Access Compliance Report

Public Rights-of-Way

(Curb Ramps)

Intersection ID: 23165	Main Street: GREYCREST_DR	Cross Street: STEELE_CREEK_RD	Location: W
ADA ID: 9145DC7481C7	Ramp Type: PerpDiag	Initial Pass/Fail: Fail	Overall Compliance: No
Severity Score: 33.75			
Codes/Mitigation Info/Possible Solution		Field Measurements/Component Compliance

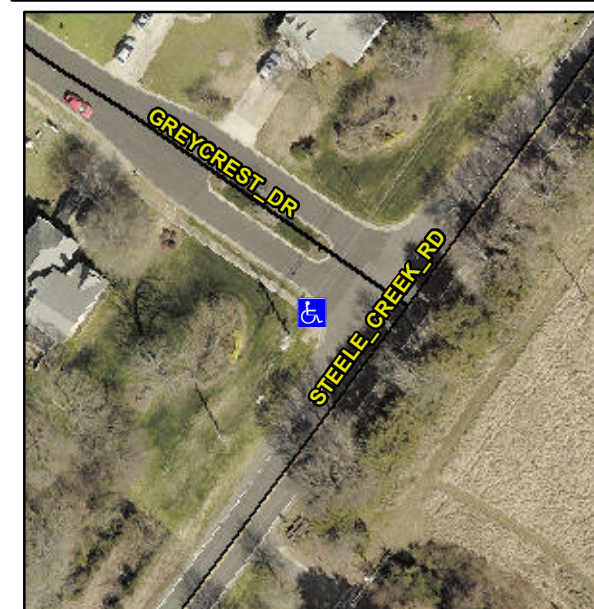
Not Found, R304.5.1, R304.2.2

Compliance	Description	Data	Compliance	Description	Data
N/A	Ramp Length (in)	48.0	No	Ramp Slope (%)	12.1
No	Ramp Width (in)	47.0	Yes	Ramp XSlope (%)	0.5
N/A	Flare Type LT	N/A	N/A	Flare Type RT	N/A
N/A	Flare Slope LT (%)	N/A	N/A	Flare Slope RT (%)	N/A
N/A	Flare Traversable LT?	N/A	N/A	Flare Traversable RT?	N/A
N/A	Landing Length (in)	N/A	N/A	DWS Provided?	N/A
N/A	Landing Width (in)	N/A	N/A	DWS Contrast?	N/A
N/A	Landing Slope (%)	N/A	N/A	DWS Length (in)	N/A
N/A	Landing X Slope (%)	N/A	N/A	DWS Full Width?	N/A
N/A	Landing Curb? (Y/N)	N/A	N/A	DWS Offset (in)	N/A
N/A	Shared Landing?	N/A			
N/A	Gutter Ponding?	N/A	N/A	Gutter Slope (%)	N/A
N/A	Gutter Lip Ht (in)	N/A	N/A	Gutter X Slope (%)	N/A
N/A	Painted X Walk1?	No	N/A	Painted X Walk2?	No
	X Walk 1 Direction	To SE		X Walk 2 Direction	To NE
N/A	X Walk 1 Width (in)	N/A	N/A	X Walk 2 Width (in)	N/A
	X Walk 1 Slope (%)	4.4		X Walk 2 Slope (%)	3.4
	X Walk 1 X Slope (%)	3.5		X Walk 2 X Slope (%)	1.2

Remove & Replace Curb Ramp With Two New Directional Ramps or Equivalent.
